I-10 LAKE CHARLES CALCASIEU RIVER BRIDGE

Final Environmental Impact Statement

State Project Number: H.003931

September 11, 2023

Figure 58b- FIRM Map 22019C0480F, effective on 2/18/2011

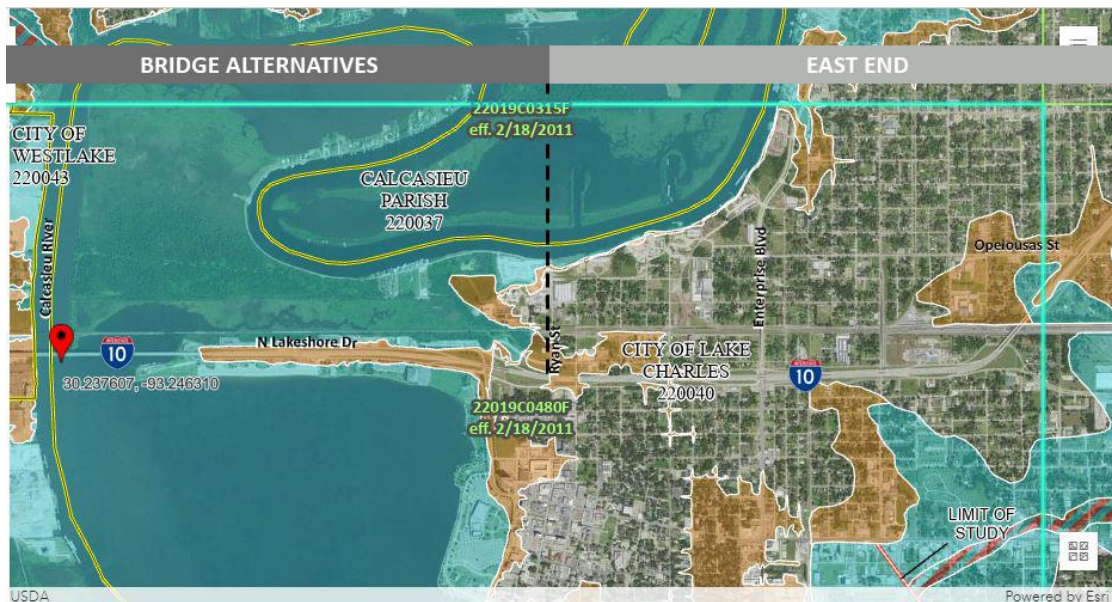
21. Figure 58, Flood Hazard Area, has been revised.

Figure 58b illustrates the base floodplain on the east side of the Calcasieu River which includes the Bridge Alternatives area of the Project and East End Improvements.

Figure 58b illustrates that the BFE for the base floodplain in this area is nine (9) feet. The elevation of the at-grade portions of alignment of I-10 in this area is proposed to be approximately 16 feet or seven (7) feet above the BFE. The elevation of North Lakeshore Drive would be approximately 15 feet (see Appendix H, Alternative 5G, Sheet 1 of 2, Vertical Profile).

The area shown on **Figure 58b** is surrounded by water bodies including the lake (Lake Charles) to the south, the Calcasieu River to the west, and a large, forested wetland to the north. The UPRR could impede flow into the north wetland. But conveyances to the west and to the south would be constructed to maintain flow through and around the encroachment of I-10 and North Lakeshore Drive to the lake and to the Calcasieu River. Covering approximately two square miles, the lake is connected to the Calcasieu Ship Channel and other waterways that flow to the Gulf of Mexico.

Figure 58c- FIRM Maps 22019C0480F and 22019C0485F, effective on 2/18/2011

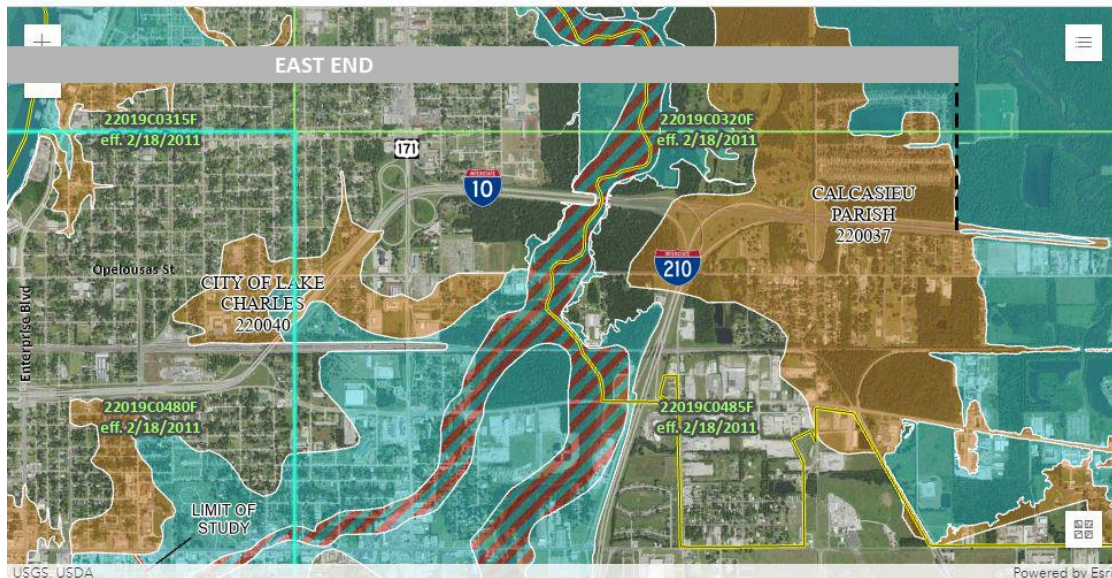
Encroachments exist upon the floodplain at the US 90 Bridge over I-10 on the West End of the project corridor (**Figure 58a**) and upon the floodplain on the East End where the Kayouche Coulee crosses under I-10 (**Figure 58c**). This waterway is identified by FEMA as a regulatory floodway, which is defined in 23 CFR §650.105 as a floodplain area that is reserved in an open manner, i.e., unconfined or unobstructed either horizontally or vertically, in order to provide for the discharge of the base flood so that the cumulative increase in water surface elevation is no more than a designated amount (not to exceed one foot as established FEMA) for administering the NFIP.

Figure 58c shows the base floodplain relative to the East End limits of the project and the Kayouche Coulee, a designated regulatory floodway in the floodplain (hatched area) which crosses existing I-10.
